Project	IEEE 802.16 Broadband Wireless Access Working Group < http://ieee802.org/16 >	
Title	Corrections on Unsolicited RNG-RSP in Non-transparent RS System under Centralized Scheduling	
Date Submitted	2007-07-05	
Source(s)	Kanchei (Ken) Loa, Yi-Hsueh Tsai, Yung-Ting Lee, Hua-Chiang Yin, Shiann-Tsong Sheu, Youn-Tai Lee,	Voice: +886-2-27399616 Fax: +886-2-23782328 loa@iii.org.tw
	Institute for Information Industry 8F, No. 218, Sec. 2, Dunhua S. Rd., Taipei City 106, Taiwan	
Re:	IEEE 802.16j-07/019: "Call for Technical Comments Regarding IEEE Project 802.16j"	
Abstract	This contribution proposes the modified figures of MS unsolicited RNG-RSP in non-transparent RS system under centralized scheduling scheme based on comment #1141 of 80216j-07_014r4.cmt.	
Purpose	Text proposal for 802.16j Baseline Document.	
Notice	<i>This document does not represent the agreed views of the IEEE 802.16 Working Group or any of its subgroups. It represents only the views of the participants listed in the "Source(s)" field above. It is offered as a basis for discussion. It is not binding on the contributor(s), who reserve(s) the right to add, amend or withdraw material contained herein.</i>

Correction on

Table 201x—Unsolicited RNG-RSP triggered by uplink traffic in non-transparent mode

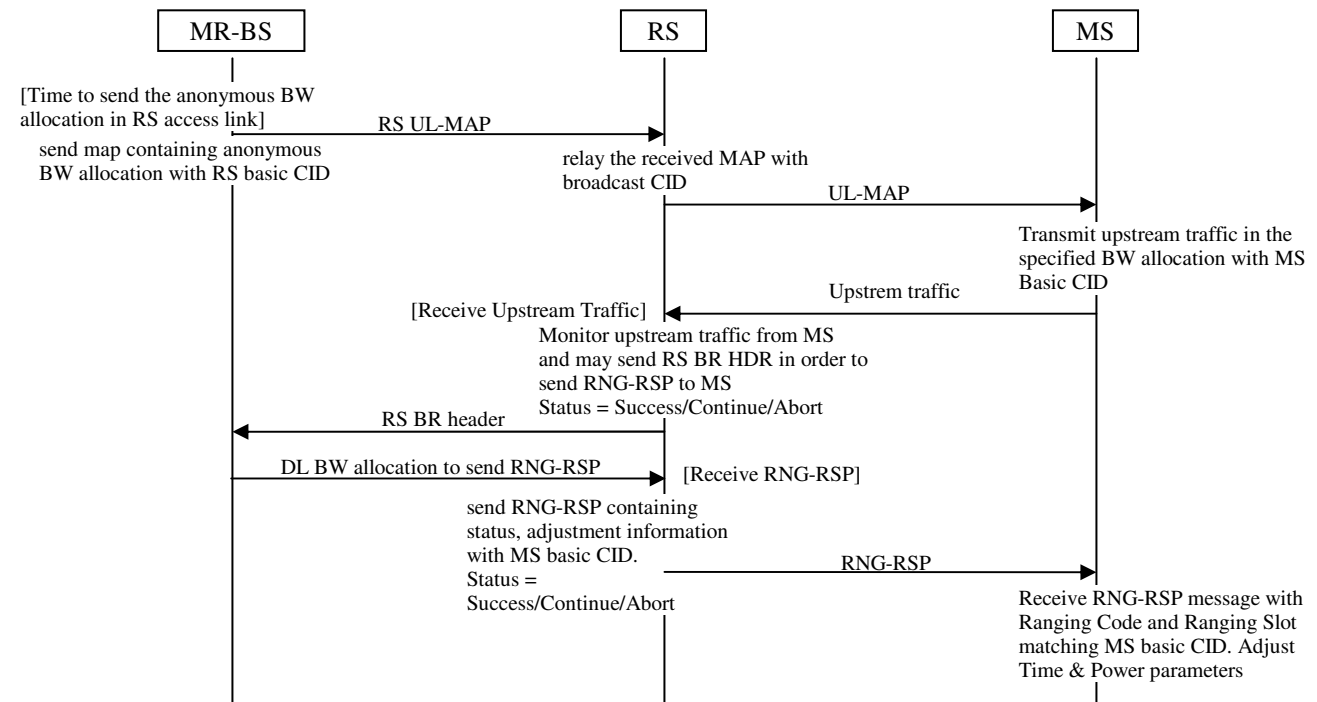
The message sequence charts (Table ~~364~~201x, Table ~~uuu~~201f) and flow charts (Figure ~~uuu~~108x and Figure ~~vvv~~108j) define the unsolicited RNG-RSP process that shall be followed by compliant RSs and MR-BSs.

[Inserted the following Table in page 101 as indicated]

Figure 108x—Unsolicited RNG-RSP triggered by upstream traffic at Access non-transparent RS

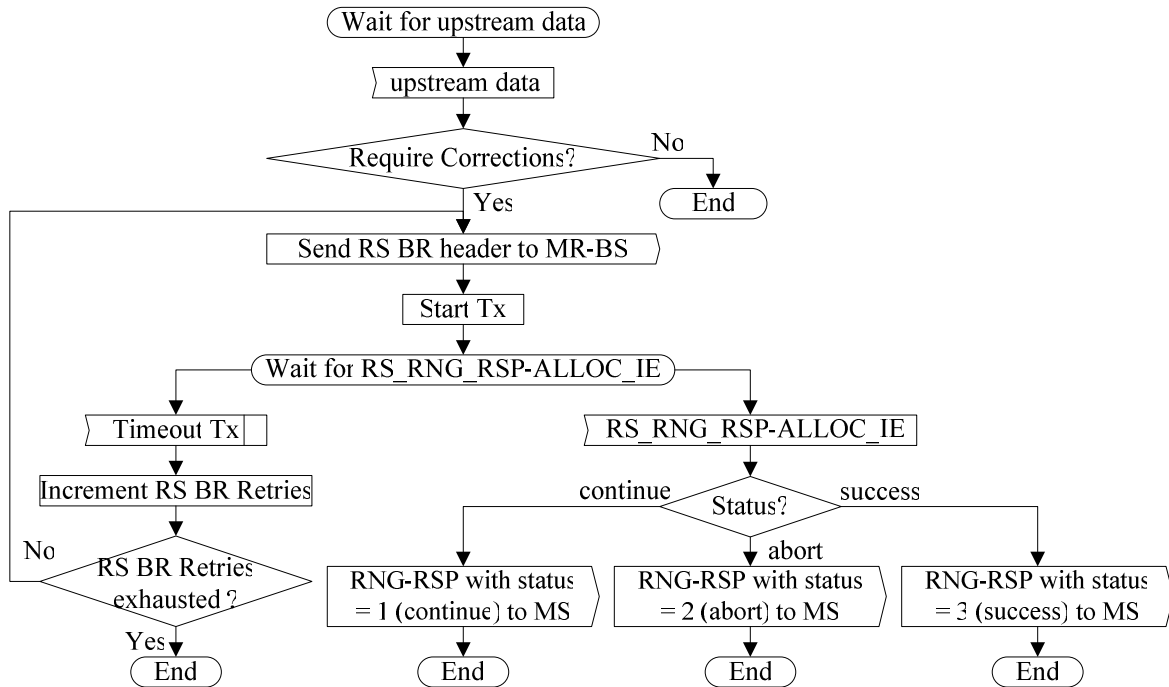
[Inserted the following figure in page 101 as indicated]

Figure 108j—Unsolicited RNG-RSP triggered by BR ranging code at Access non-transparent RS

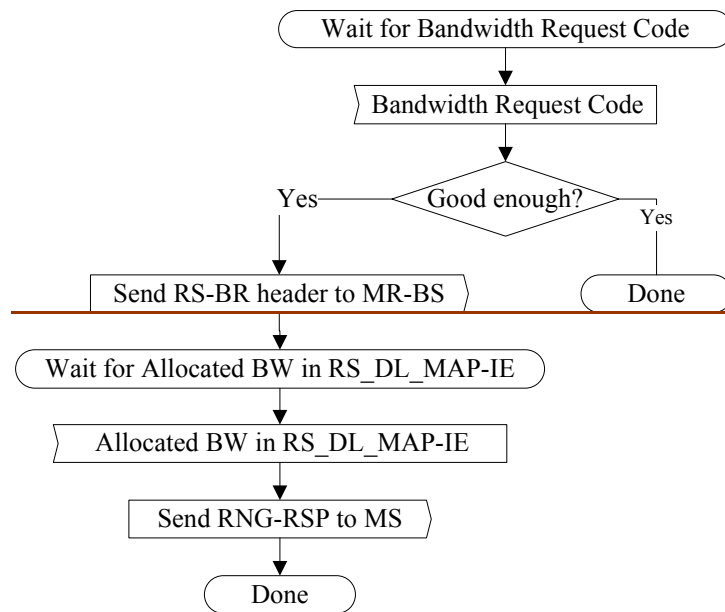
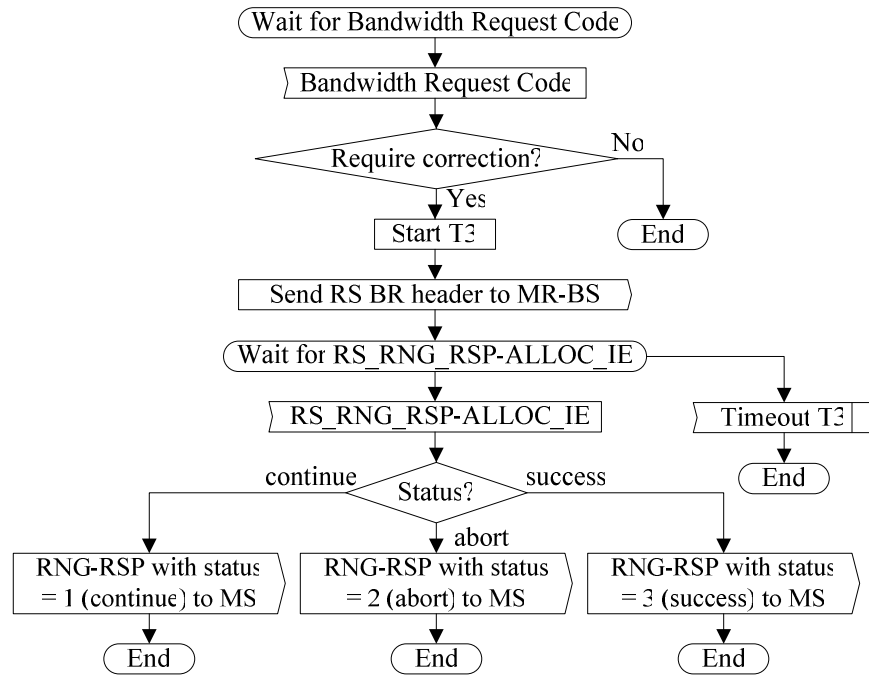
[Replaced the following figure in page 101 as indicated]

Figure 108k—Unsolicited RNG-RSP triggered by BR ranging code in non-transparent RS system—MR-BS

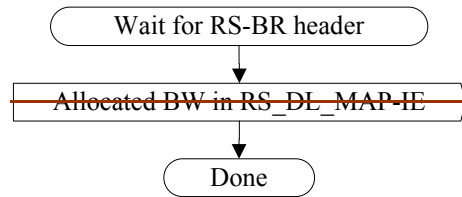
[Deleted the following figure in page 101 as indicated]
